## ORIGINATION FORM

Proposed Revisions to a Standard Plans Index  
(Please provide all information — Incomplete forms will be returned)

Index Number: 649-010

Index Title: Steel Strain Pole

HANDHOLE

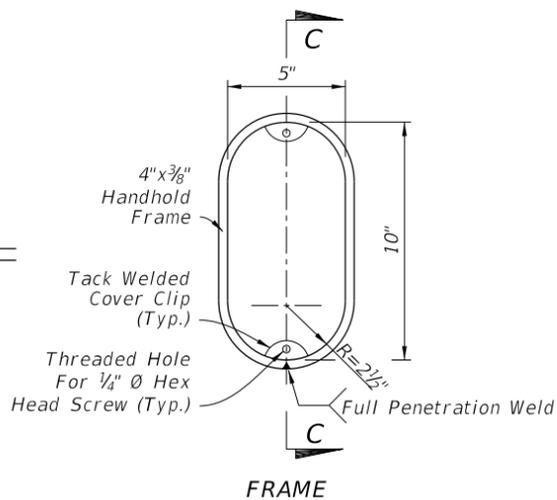
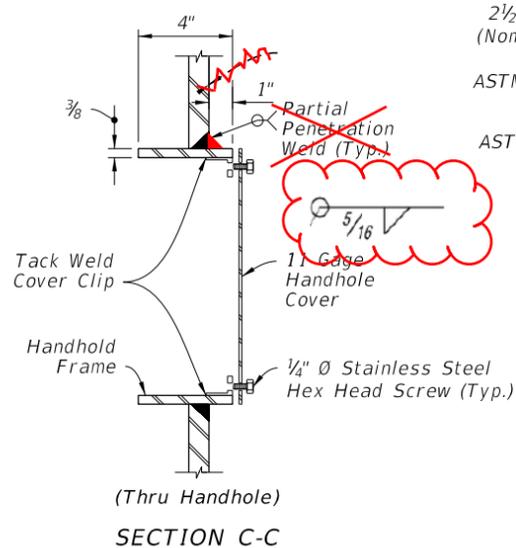
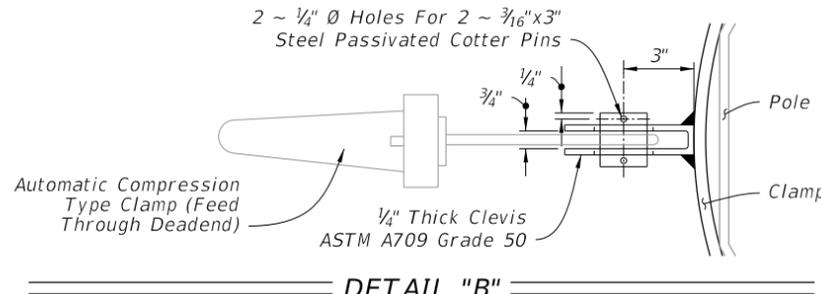
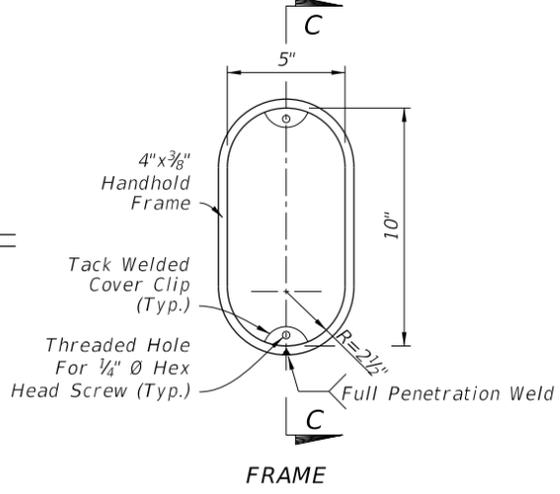
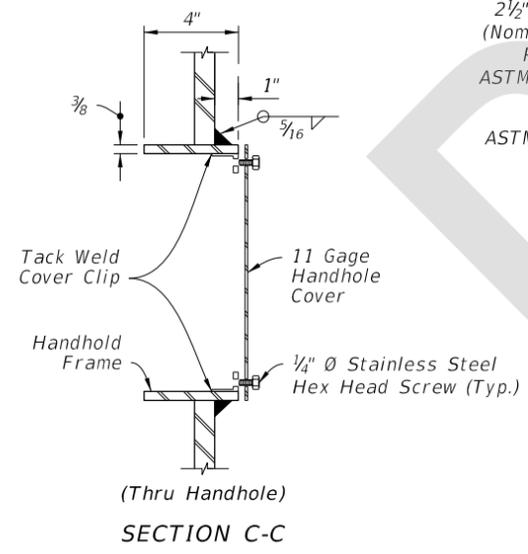
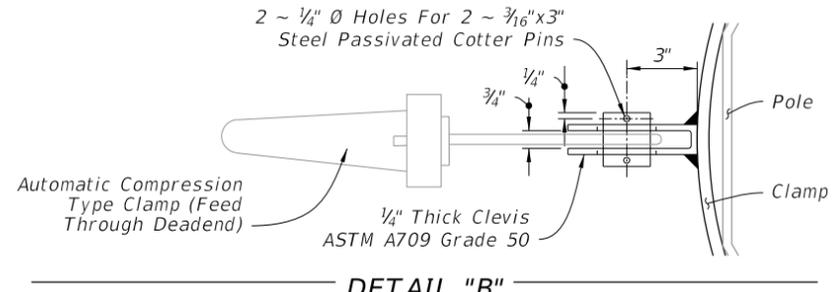
Sheet 3: Change weld on Handhole.
